ORDINANCE #123

AN ORDINANCE OF THE CITY COUNCIL OF CENTERVILLE, MINNESOTA,  
APPROVING A CONDITIONAL USE PERMIT FOR A PLANNED UNIT DEVELOPMENT  
FOR THE FAIRVIEW SECOND ADDITION PLAT

## Planning Report

#### RE: Banjo Distribution Center, PUD, Preliminary & Final Plat

**Banjo  
Distribution  
Facility  
Applicant's  
Site Plan**

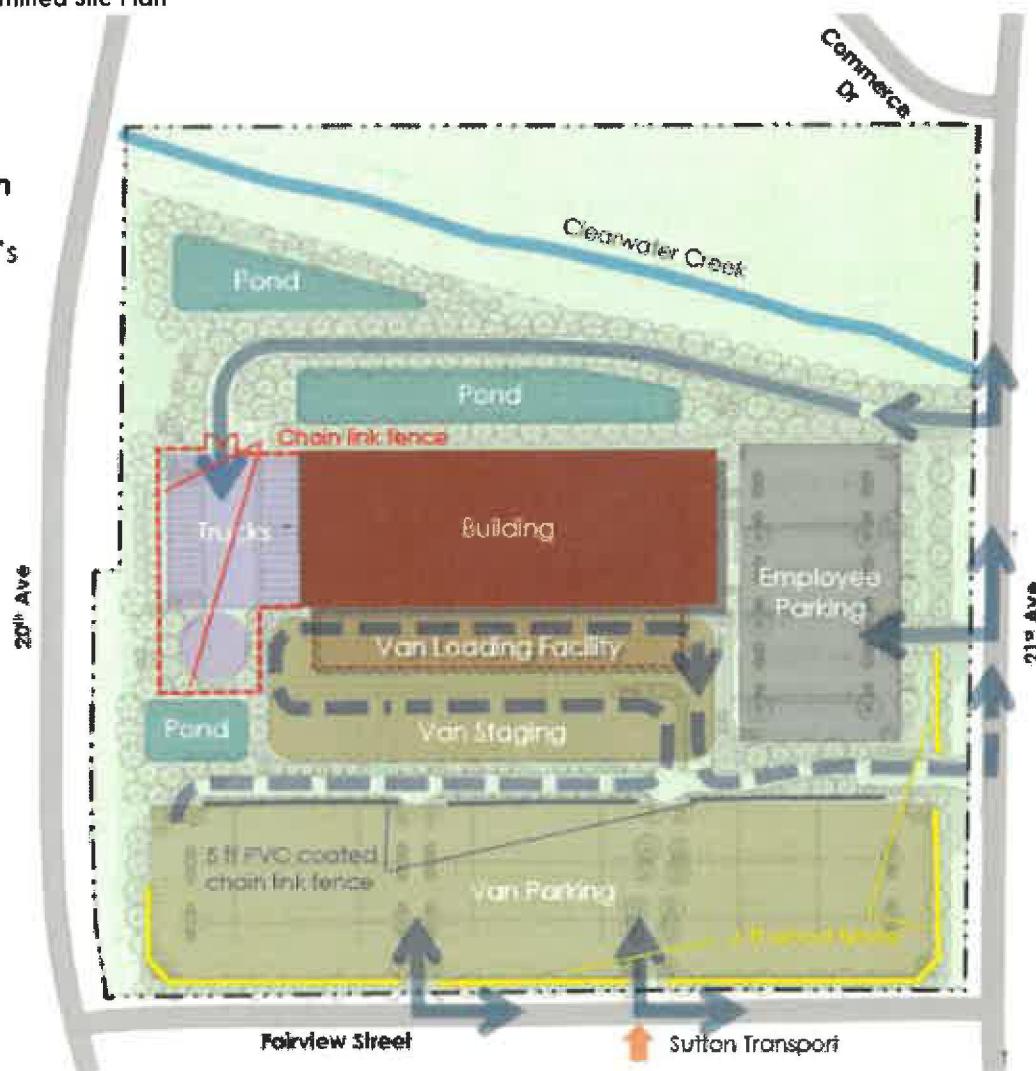
Below is the originally submitted site plan, in schematic form. Some revisions to the plan are discussed throughout this memo.

**East Elevation (toward 21<sup>st</sup> Avenue)**

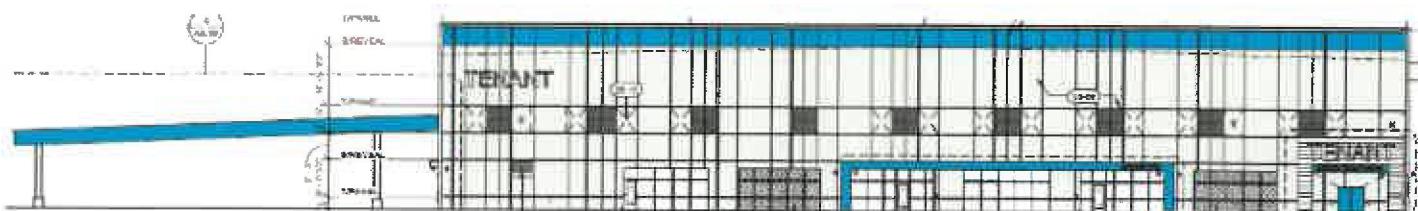
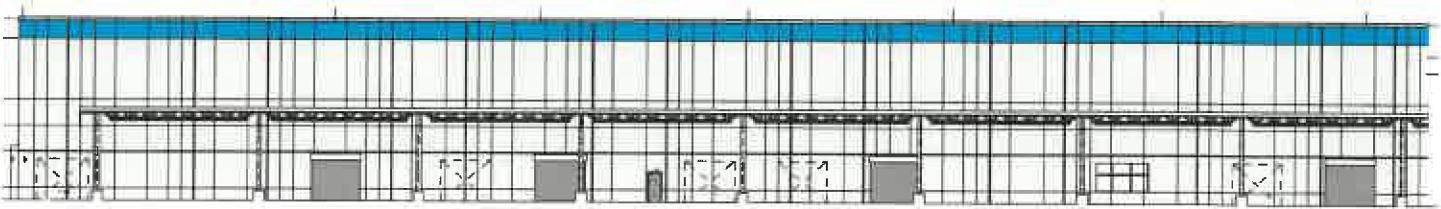
The building is proposed to be 44 feet in height. Code allows buildings over 35 feet in height by CUP and with increased setbacks. This issue is dealt with in the PUD.

The exterior materials of the building are proposed to be precast concrete panels painted gray, with a colored band at the top – see elevation and oblique site views below and on the next pages. There will be glass windows on the front (east) side where the offices are located. There are reveals in the concrete panels to lend interest, but what is proposed is essentially a very large gray box with a stripe around the top. The code in Section 156.040 (P) requires:

*Industrial buildings are required to be constructed of brick, decorative block or approved textured masonry product. Pole barn type buildings are not allowed. Buildings are required to have contrasting architectural features and must be designed to be aesthetically pleasing.*

**Figure 3: Daytime Operational Noise Contours**

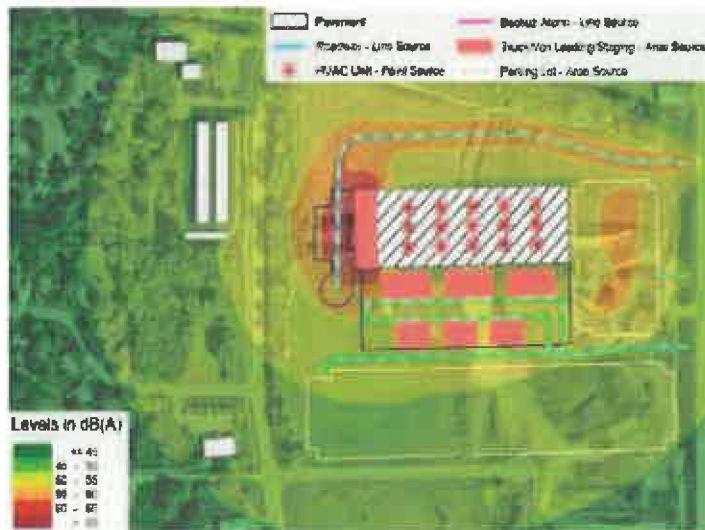
Estimated noise contours in the area from the memo are on the next page. I spoke with the memo's author, Tad Hardy of Kimley-Horn Charlotte NC office, who offered the following:

- The memo estimates existing ambient noise as 45-50 dB(A). This is an estimate based on experience with similar suburban settings and did not involve actual measurements or noise monitoring on site. This existing ambient noise will be measured as a condition of approval to determine a baseline before construction begins.

- The memo estimates noise from the various sources at the Banjo project site as 44-48 dB(A).
- Not directly stated in the memo is the additive effect of the existing noise plus the project noise. Mr. Hardy said that adding the existing 45-50 dB(A) to the new 44-48 dB(A) amounts to an additional 1-3 dB(A) – the cumulative noise that would be experienced once the project is operational would likely be 46-53 dB(A), still below the city and state noise standards.

- 1) Existing noise levels in the neighborhood are modest.
- 2) New noise from various sources on the Banjo site would also be modest.
- 3) The combination of existing and new noise levels would be an additional 1-3 dB(A), a small increase.

- 4) A wall, fence, or berm would not be effective in noticeably reducing noise from the site.
- 5) Existing noise levels should be measured before construction begins, then again after the site is operational to confirm the conclusions of the study, and to help the City decide if additional mitigation measures might be warranted.

**Banjo Distribution Facility Applicant's Revised Site Plan**

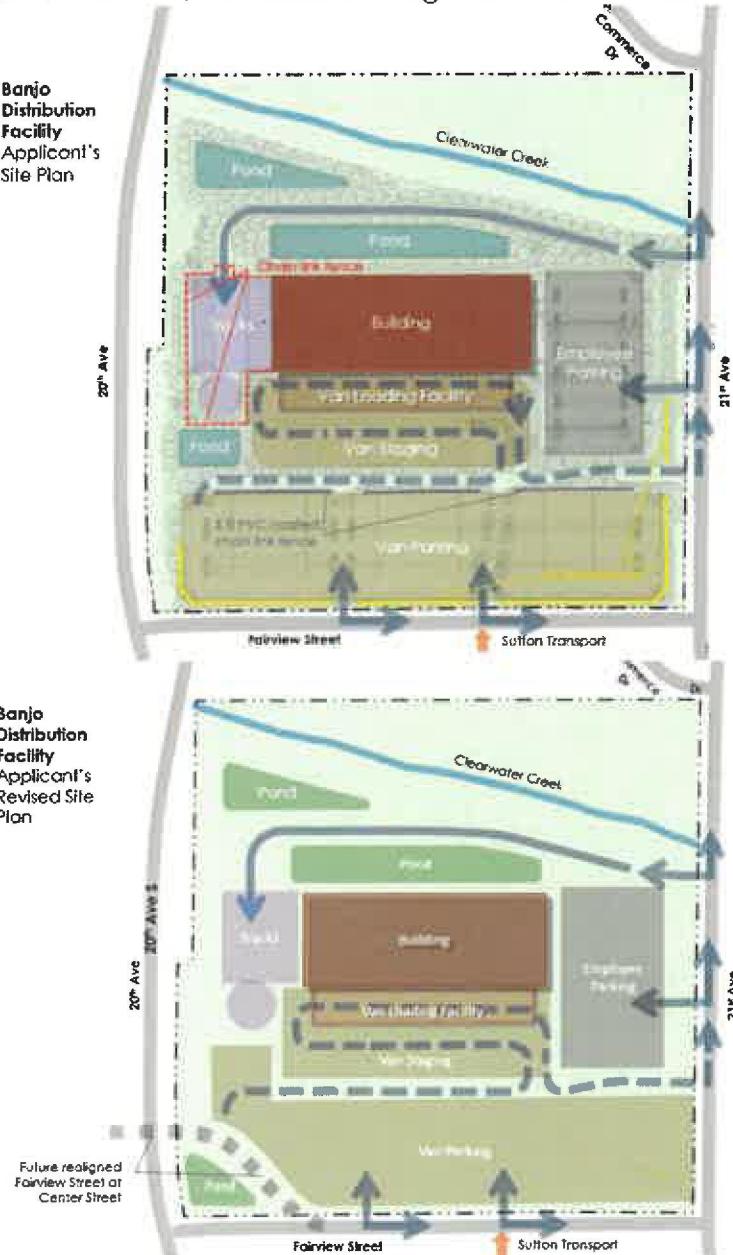
The intersection of Fairview Street, Center Street and 20<sup>th</sup> Avenue is askew, with Center Street and Fairview Street being approximately 250 feet apart. With the relatively low volume of traffic on either side road, this intersection alignment has not caused major issues, to date. However, with the intensification of traffic on Fairview, combined with growing traffic volumes on 20<sup>th</sup> Avenue (CSAH 54), the intersection alignment could become a problem. In particular, if a traffic signal or roundabout were ever warranted at this location, Fairview and Center Street would need to be aligned. With this in mind, the applicant has provided an alternative site plan (below, left).

With this new site layout, the city and county would be able to realign Fairview Street, without the cost of reconfiguring Banjo's parking lot. The new site layout allows for flexibility in Fairview's alignment, whether for a signal or roundabout.

With this proposal, Banjo would continue their commitment to a \$650,000 contribution towards area transportation improvements, but would not build the turn lane on 20<sup>th</sup> Avenue. Obviously, it would not make sense to construct a turn lane on 20<sup>th</sup> Avenue, if ultimately, Fairview Street was realigned for either a signal or roundabout.
